SUBJECT: ISSUANCE OF AMENDMENT NO. 60 TO FACILITY OPERATING LICENSE NO. DPR-18, R. E. GINNA NUCLEAR POWER PLANT (TAC NO. M92188)

Amendment No. 60
License No. DPR-18

SAFETY EVALUATION BY THE OFFICE OF NUCLEAR REACTOR REGULATION
RELATED TO AMENDMENT NO. 60 TO FACILITY OPERATING LICENSE NO. DPR-18
ROCHESTER GAS AND ELECTRIC CORPORATION
R. E. GINNA NUCLEAR POWER PLANT
DOCKET NO. 50-244

Figure 5.4-2
 Fuel Assembly Burnup Limits in Region 2

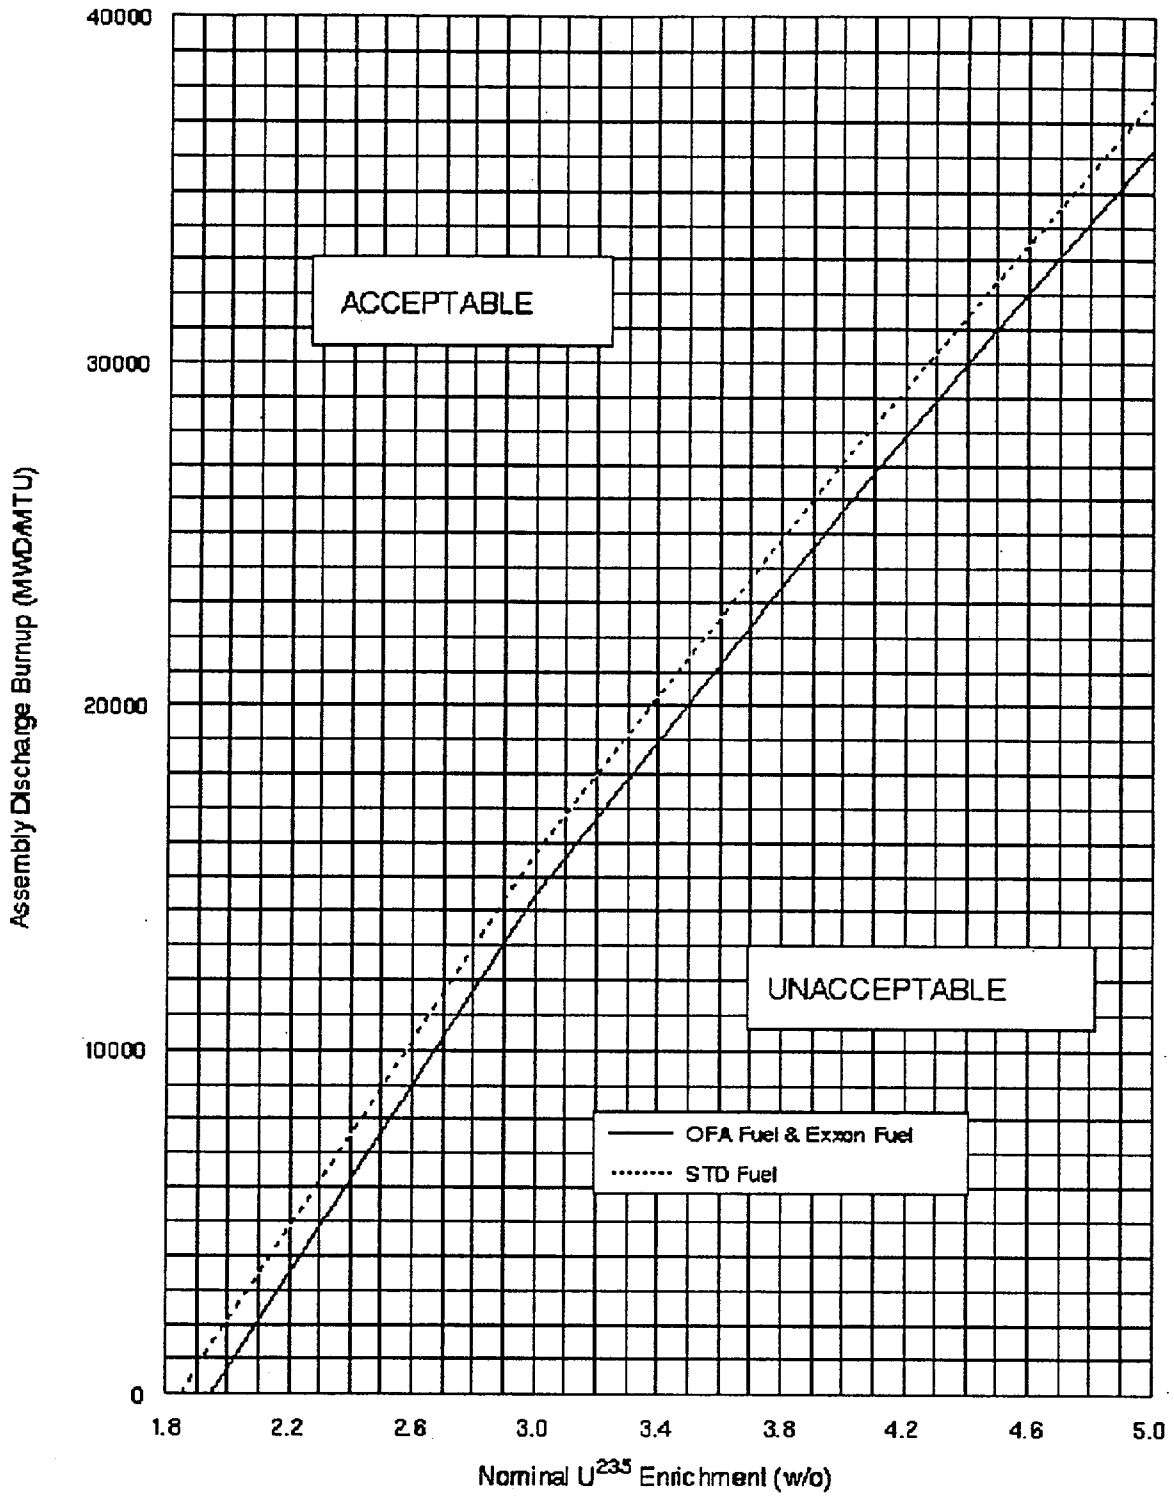
The two curves of Figure 5.4-2 divide the fuel assembly designs into two groups. The first group is all fuel except Exxon fuel delivered prior to January 1, 1984, which incorporates all Westinghouse HIPAR designs used at Ginna.⁴ The second curve is for all Exxon fuel, as well as the Westinghouse Optimized Fuel assembly design delivered to Ginna beginning in February 1984.³

The calculations of fuel assembly burnup for comparison to the curves of Figure 5.4-2 to determine the acceptability for storage in Region 2 shall be independently checked. The record of these calculations shall be kept for as long as fuel assemblies remain in the pool.

In order to store Westinghouse 14x14 OFA as well as Westinghouse STD and Exxon 14x14 assemblies with enrichments up to 5.0 w/o U-235, the concept of burnup credit reactivity equivalencing was used. This is predicted upon the reactivity decrease associated with fuel depletion and has been previously accepted by the staff for spent fuel storage analysis. For burnup credit, a series of reactivity calculations are performed to generate a set of initial enrichment versus fuel assembly discharge burnup ordered pairs which all yield an equivalent K_{eff} less than 0.95 when stored in the spent fuel storage racks. The results indicate that a fresh OFA 1.95 w/o enriched fuel assembly yields the same rack reactivity as an initially enriched 5.0 w/o OFA depleted to approximately 36,200 MWD/MTU. Since the Westinghouse 14x14 STD is more reactive than the Westinghouse 14x14 OFA fuel at the low enrichment limit for the Region 2 rack, a separate burnup credit curve was determined for the STD fuel. In addition, since the Exxon 14x14 fuel is less reactive than the Westinghouse OFA, the Westinghouse 14x14 OFA burnup credit curve may be used for the Exxon 14x14 fuel. A reactivity uncertainty of 0.0121 K (reactivity increase) was applied to the burnup credit curves. This is consistent with current practice and is acceptable.
